**CERTIFICATE OF APPROPRIATENESS**

**Property:** 1123 Oxford Street, Lot 7, Block 196, Houston Heights Subdivision. The property includes a historic 2,146 square foot, one-story wood frame single-family residence and detached garage situated on a 6,600 square foot (50' x 132') interior lot.

**Proposal:** Alteration – The applicant was denied a COA at the June HAHC meeting to construct a rear 1 and 2-story addition with an attached garage to a contributing one-story residence. The applicant resubmitted the application with two revisions to the original proposal:

**NORTH SIDE ELEVATION**

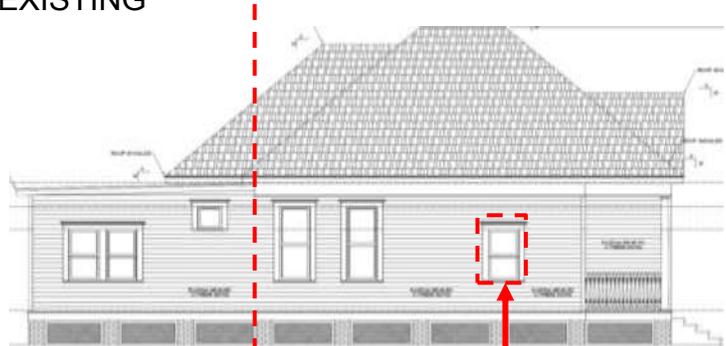
- The one-story side addition on the north elevation will be inset 3'-8" from the existing north wall and the proposed gable roof and set of shutters have been removed. The one-story addition will measure 8'-3" wide and 12'-4" deep.
- The rear addition will be inset 6" on the south elevation at the original rear corner.

Agenda # 31 - 1123 Oxford - I OBJECT to the granting of a Cof A for this proposal based on one issue. The applicant proposes to alter the roof line of the existing structure by the addition of a roof portion at the side of the original structure. This will alter the character of the existing structure and is not compatible with the unique style of the existing house.

1123 Oxford— Support as drawn. I like the small 1-st story gable on the North wall because that helps the addition meet criteria 5: "*the proposed activity must maintain or replicate distinctive stylistic exterior features or example of skilled craftsmanship that characterize the building, structure, object or site.*" This small detail makes the final product MUCH better looking than the boring boxes the commission/staff is forcing people to build. I like Criteria 5, and think that recommending the owner to remove this great architectural detail is directly counter to Criteria 5. If the Ordinance was supposed to force people to build boring boxes, then it needs to say that. This addition starts at the back of the original structure. so I do not understand the basis for which they are being recommended for denial.

I OBJECT to granting a Certificate of Appropriateness for this application. The addition of a gable feature to the existing Queen Anne simplistic style historical house will provide a different visual characteristic not usually found in this type of architecture and would essentially be introducing a different style feature to the historic house. New additions to existing historic structures should be visually differentiated from the existing structure either by inseting the new addition or some other visual cue. This proposal would extend the existing structure without differentiation so that the new addition would seem to be a part of the existing historic structure which is the antithesis of intent. An addition to an existing historic structure should be a visual backdrop to the existing structure and allow the addition to be visually secondary to the predominant existing historical house.

**ROOF PLAN**

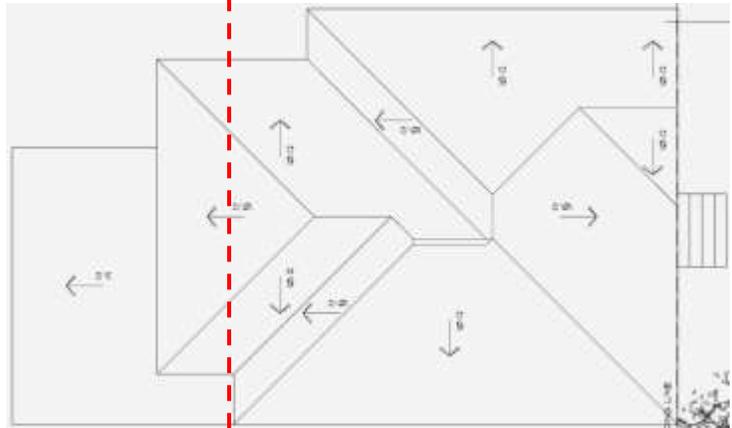
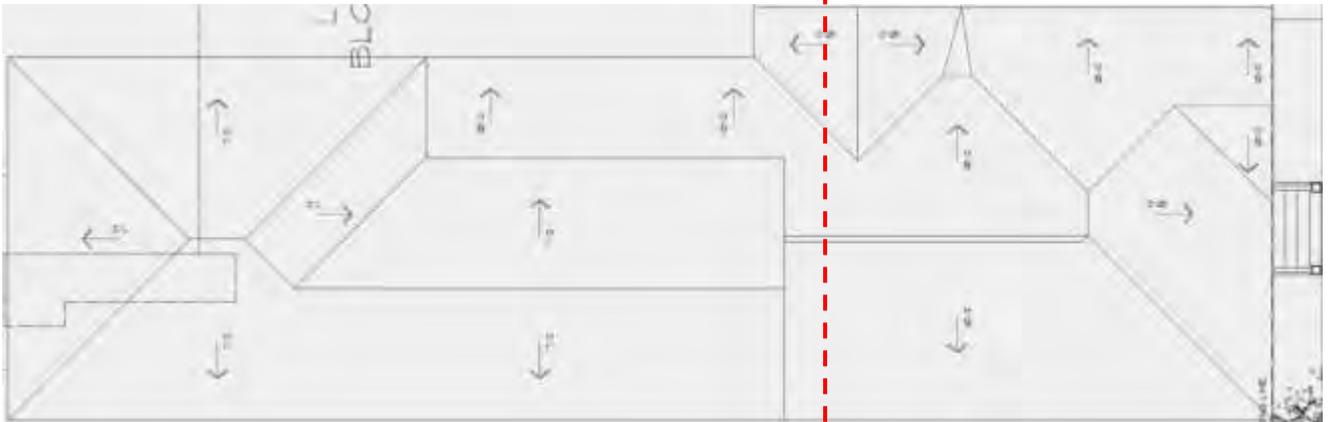
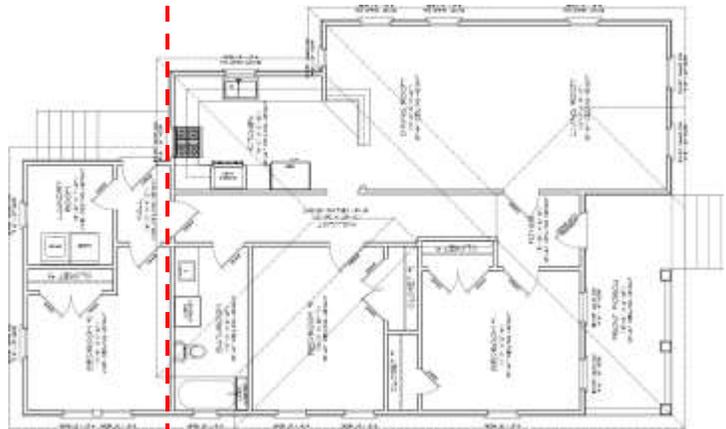
**Roof:** The residence features a 10/12 gable on pyramid hip roof. The non-original addition features a 3/12 shed roof. The roof is clad with composite shingles. The one-story addition will *tie into the proposed first floor 10/12 hip roof (previously proposed side gable roof with a 10/12 pitch)*. The 2-story addition will feature a 7/12 gable on hip roof. The roof will be clad with composite shingles.
